DOCUMENT CHANGE REQUEST

DCR number 328	Changes required for: General	Originator: S JEFFERY
Date: 2007/04/17	Date sent: 2007/04/17	Organisation: ESA/ESTEC
Status: IMPLEMENTED

Title:	Matched Dual Transistors NPN, based on type 2N3350		
Number:	5207/003	Issue:	1

ESCC Detail Specification No. 5207/003

1.6.1 Metal Can Package (TO - 77) - 6 lead

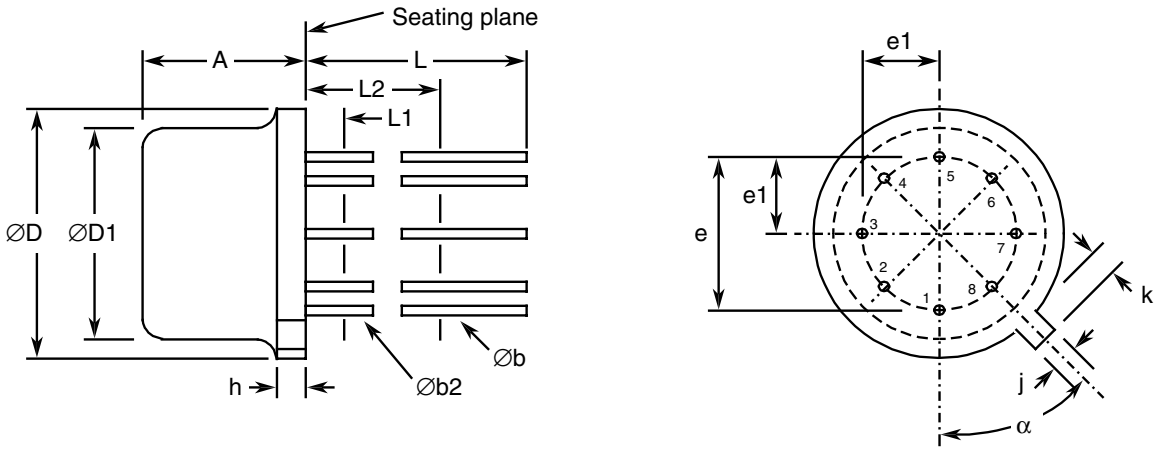
6. Para. 4.3.2 Weight requirements moved to Component Type Variants table.
7. Figure 2 re-named â..Physical Dimensions and Terminal Identificationâ.; Figure 2(a) amended to reflect the TO-77 package currently supplied; Figure 2(b) amended to reflect the CCP package currently supplied.

1.7 FUNCTIONAL DIAGRAM

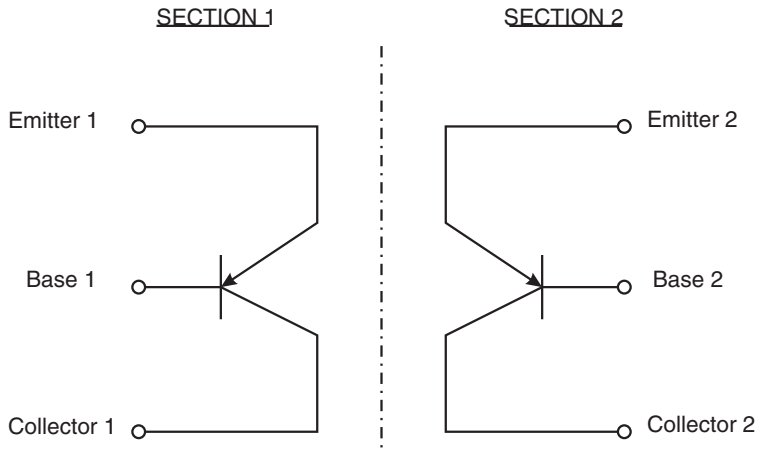
8. Figure 3 Functional Diagram amended and Notes added.
9. Para. 4.3.3 Terminal Strength: Erroneous text â..Applied Force: 2.5Â±0.1 Newtonsâ. deleted.
10. Para. 4.4.1 Case requirements corrected to reflect a TO-77 metal can package.

NOTES:
1. For TO-77, the case is not connected to any lead.
2. For CCP, the lid is not connected to any terminal.
